10125 mm CURVED SWITCH WITH
ZU-1-60/60E1A1 THICK-WEB TONGUE
RAILS FOR 1 IN 12 TURNOUT
B.G. (1673 mm) FOR 60 kg (UIC)/60E1
ON P.S.C. SLEEPERS

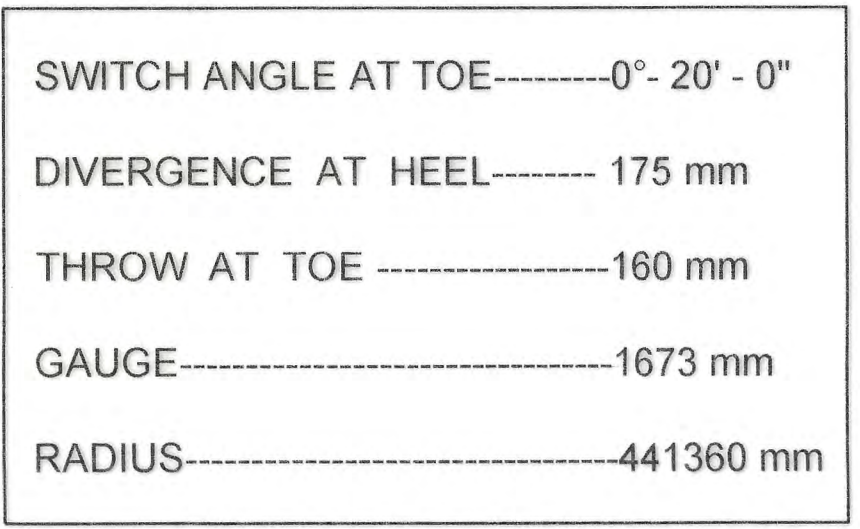
xii)	PLATE SCREWS TO DRG. No. RSDOT-3912 ARE REPLACED WITH DRG. No. RSDOT-3913
xiii)	NOTE No. 8, 1 & 4.8 IS MODIFIED
xiv)	NEW DISTANCE BLOCK TO DRG. No. RSDOT- 9933 & RSDOT- 9934 ADDED BETWEEN SLEEPER No. 22 & 23
xv)	NEW INSULATED PLATE FOR S&D TO DRG. No. RSDOT- 9632 TO RSDOT- 9633/1 ADDED AND INSULATED PLATE FOR S&D TO DRG. No. RSDOT- 6279/1 TO RSDOT- 6279/2 DELETED ON SLEEPER No. 13
xviii)	NEW NYLON CORP REINFORCED GRSP TO DRG. No. RSDOT- 9936 ADDED AND NYLON CORD REINFORCED GRSP TO DRG. No. RSDOT- 8900 TO RSDOT- 8910 DELETED FROM SLEEPER No. 25 TO 27
xix)	NEW CAST STEEL SPECIAL BEARING PLATE TO DRG. No. RSDOT- 9617 TO RSDOT- 9629 ADDED AND M.S. SPECIAL BEARING PLATE TO DRG. No. RSDOT- 6767 TO RSDOT- 679 DELETED FROM SLEEPER No. 21 TO 27
xx)	NEW CAST STEEL SLIDE CHAIR TO DRG. No. RSDOT- 9616 ADDED AND M.S. SLIDE CHAIR TO DRG. No. RSDOT- 6166 DELETED FROM SLEEPER No. 04 TO 20
xxi)	NEW M.S. PLATE TO DRG. No. RSDOT- 9931 ADDED AND M.S. PLATE TO DRG. No. RSDOT- 3801 DELETED ON SLEEPER No. 04

xxii)	NEW CAST STEEL AND M.S. STEEL EXTENDED THE PLATE (INSULATED) TO DRG. No. 9953 TO RSDOT- 9953/3 ADDED AND INSULATED THE PLATE TO DRG. No. RSDOT- 6156 TO RSDOT- 6156/2 DELETED ON SLEEPER No. 03
xxiii)	METAL LINER TO DRG. No. RSDOT- 3740 ADDED AND INSULATING LINER TO DRG. No. 3740 DELETED
xxiv)	ELASTIC RAIL CLIPS MK-1 TO DRG. No. RSDOT- 5919 ADDED AND ELASTIC RAIL CLIPS MK-II TO DRG. No. RSDOT- 3701 DELETED

i)	BEND IS PROVIDED IN M.S. FLAT THE BAR TO DRG. No. RSDOT- 9010 ON OPPOSITE SIDE OF POINT MACHINE BETWEEN SLEEPS No. 03 TO 04
